COMPLETENESS REVIEW RESPONSE

PROJECT NAME	SITE ADDRESS	CASE NO.
DISTRICT 10	2710 BROADWAY STREET NE	23-113096-PLN

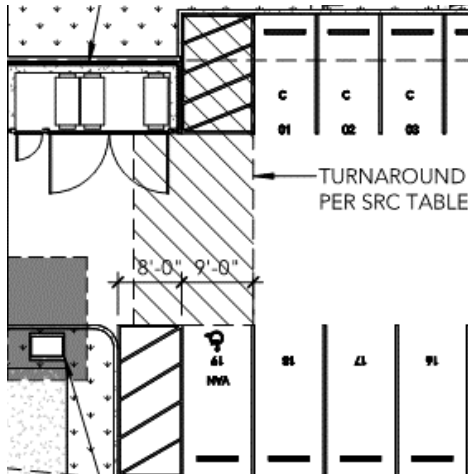
Off-Street Parking, Loading, and Driveways – SRC Chapter 806 – Off-Street Parking Area Access and Maneuvering. The proposed vehicle use area does not comply with the turnaround requirement in SRC 806.035(f), Figure 806-9. Please revise the layout to comply with the requirements of SRC Chapter 806.

RESPONSE: The vehicle maneuvering layout has been revised to comply with SRC 806.035(f), Figure 806-9 as illustrated below. This revision can be found on the updated Site Plan, Sheet SP-01.
